**ADDENDUM 1**

**BID TITLE: File 9-25 Cleveland Public Safety Roof Replacement Project Fire Station 17 & 30**

## Dept of Public Safety – Roof Replacement Project – Fire Station 17 and 30

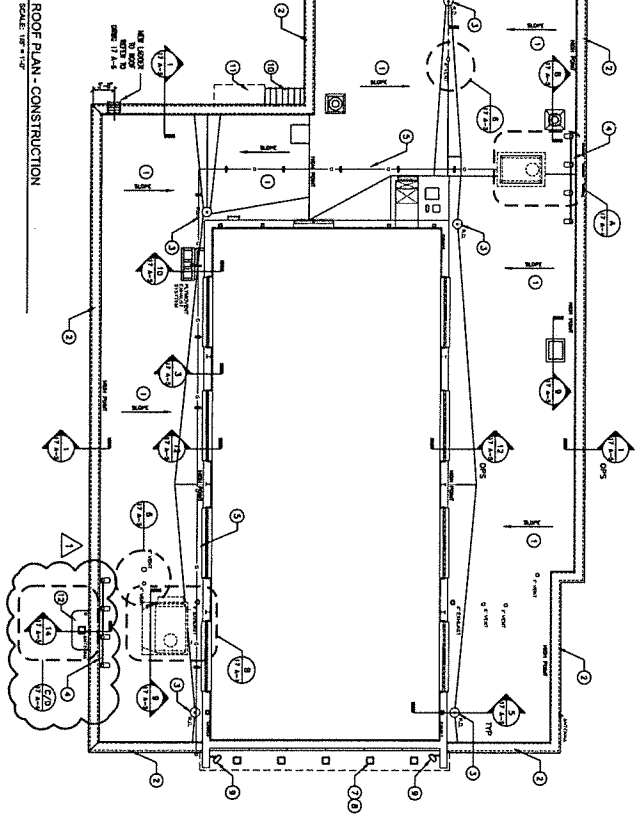
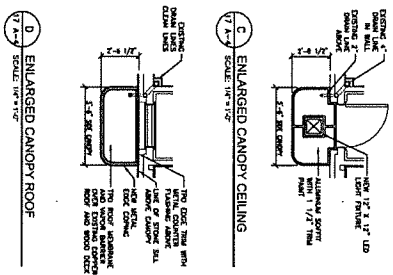
*DRAWING 17 A-4 REVISED. REVISIONS NOTED ON DRAWING. REPLACE WITH DRAWING 17 A-4 INCLUDED WITH THIS ADDENDUM.*

**IN RESPONSE TO AN INQUIRY REGARDING WHERE ARE DETAIL C ON 17 A-4 AND DETAIL D ON 17 A-4:  
*CONTRACTOR TO REFER TO REVISED DRAWING 17 A-4: WHICH IS ATTACHED TO THIS  
ADDENDUM.***

**IN RESPONSE TO AN INQUIRY REGARDING CONSTRUCTION NOTE ON 17 A-4 SAYS REPLACE EXISTING  
DRAIN BASKET AND RINGS. DETAIL ON 17 A-5 REFERENCE DRAIN INSERTS. ARE WE REUSING  
EXISTING DRAINS OR USING INSERTS?:  
*CONTRACTOR TO FURNISH AND INSTALL REPLACEMENT DRAINS.***

*THE CONTRACTOR SHALL REMOVE THE EXISTING METAL SOFFIT AND ANY DAMAGED METAL FASCIA AND REPLACE WITH NEW AND PAINT. THIS APPLIES TO NOTE 12 ON DRAWING 17 A-4. REVISED DRAWING ATTACHED TO THIS ADDENDUM.*

*THERE ARE TWO CANOPIES AND ONE AWNING ON FIRE STATION 17. THE REAR CANOPY, NOTE 10 AND AWNING, NOTE 11 ARE TO REMAIN AND BE PROTECTED. THE SECOND CANOPY, NOTE 12 IS TO BE REMOVED AND REPLACED WITH NEW ROOFING AND METAL.*

10. METAL CANOPY  
ENTRANCE DOORS  
SCALE: 3/4" = 1'-0"

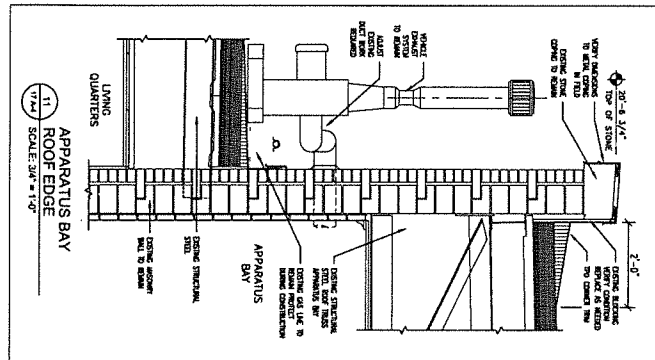
**IN RESPONSE TO AN INQUIRY REGARDING DETAIL 10 ON DRAWING 17 A-5 AND THE NOTE CUT OFF IN THE DETAIL:**
